Central City Village Planning March 12, 2018

Request To: WU Code (Walkable Urban Code)

Proposed Use: Multifamily housing

Staff Report: Z-88-17-8 February 26, 2018 Page 2 of 11

Sketch Map
Aerial
Site Plan date stamped December 21, 2017
Elevations date stamped December 21, 2017

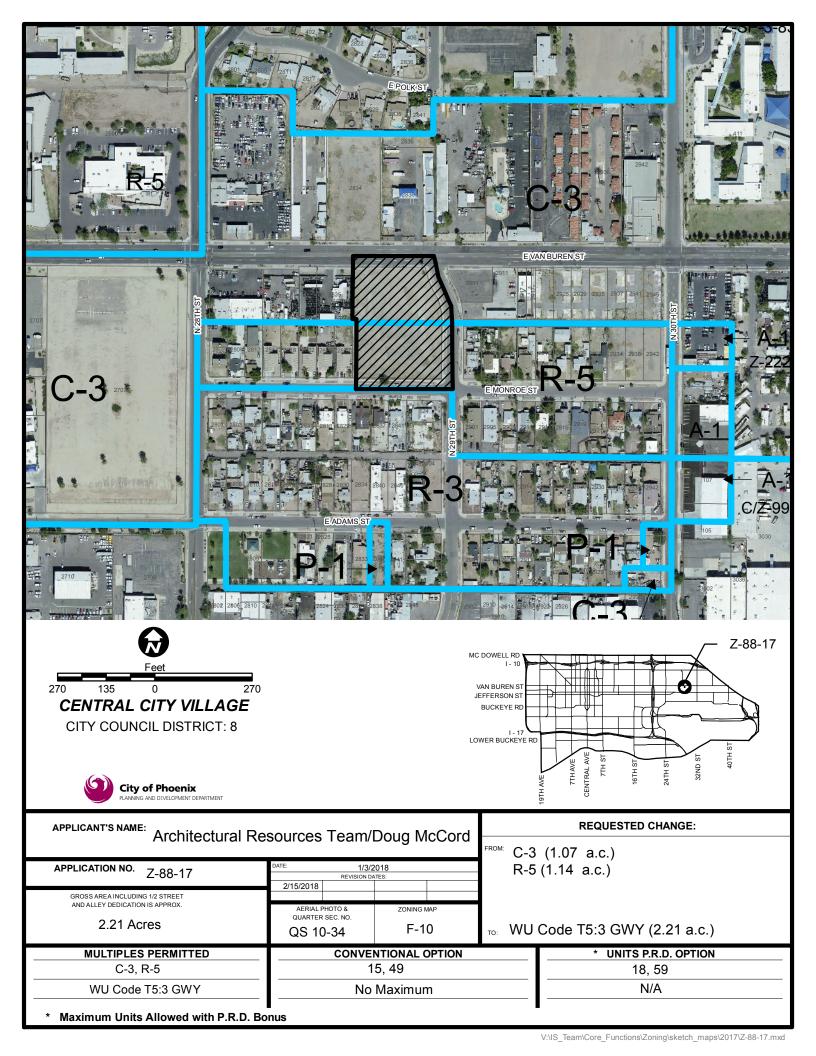
In order to provide an environment where trees can be placed without conflict with utilities, staff is recommending that root barriers be utilized for as much of the 29th Street frontage as possible. Use of root barriers will allow trees to be planted back of curb while maintaining at least a six-foot separation from the existing water line. The northern portion of the 29th Street frontage, where the water line conflict is greatest, may need a design solution that could include moving the sidewalk onto the subject site to gain the required tree planting separation from the existing water line. This is addressed in Stipulation 1.

- 10. A water line conflict has been identified running parallel with the sidewalk in the approximate seven-foot landscape area along the Monroe Steet frontage, reducing the ability to plant shade trees in the landscape strip between the sidewalk and back of curb. This utility conflict will require the applicant to consider structural shade elements, trellises, or covered walkways attached to the primary building in order to meet the minimum building and shade requirements of the WU Code Section 1304.F. for this frontage. Projections in the right-of-way are permitted with a minimum 16-foot height clearance within six feet of public water/sewer lines, unless shade is retractable or an encroachment permit is secured as administered by the City of Phoenix. Additional Frontage Standards can be found in the WU Code Section 1305. The applicant is encouraged to continue working with staff to update their proposal as it proceeds through the site development review process. This is addressed in Stipulation 2.

- 11. Although dimensions are not provided, the sidewalks are shown to be detached from the curb providing a more comfortable environment for pedestrians. This design is consistent with the City Council adopted Guiding Principles for Complete Streets, one tenet of which is to make Phoenix more walkable. This is addressed in Stipulation 3.

12. The Comprehensive Bicycle Master Plan supports options for both short- and long-term bicycle parking as a means of promoting bicyclist traffic to a variety of destinations. The conceptual site plan does not address bicycle parking at this time. It is recommended that two types of parking be provided on the property: secured parking for residents, and short-term rack parking for guests located near entrances to the building. The property is within one-half mile of a light rail transit station and adjacent to a bus routes. Providing secure bicycle parking for residents

- 14. The conceptual site plan shows the possibility of curb lines being moved on street frontages, perhaps to provide on-street parking. The developer should work with the Street Transportation and Planning and Development Department staff to identify locations for any on-street parking, however the existing curb lines should be retained. This is addressed in Stipulation 7.

- 1. The developer shall utilize root barriers to facilitate planting of trees in the 29th Street landscape area.
- The developer shall work with the Planning and Development Department to determine a frontage type appropriate for all street frontages which will also provide the shade required by the Walkable Urban Code.

- 3. Sidewalks on street frontages shall be detached from the curb by a minimum of five feet, as approved by the Planning and Development Department.
- 4. The required minimum bicycle parking spaces shall be secured and provided on site, as approved by the Planning and Development Department.

- 5. A minimum of four inverted-U bicycle racks for guests shall be provided on site, located near an entrance to the ground floor lobby, and installed per the requirements of Section 1307.H.4. of the Zoning Ordinance, as approved by the Planning and Development Department.

- 7. Any on-street parking which may be provided, shall be designated adjacent to existing curb lines on Van Buren Street, 29th Street and Monroe Street, as approved by the Street Transportation and Planning and Development Departments.
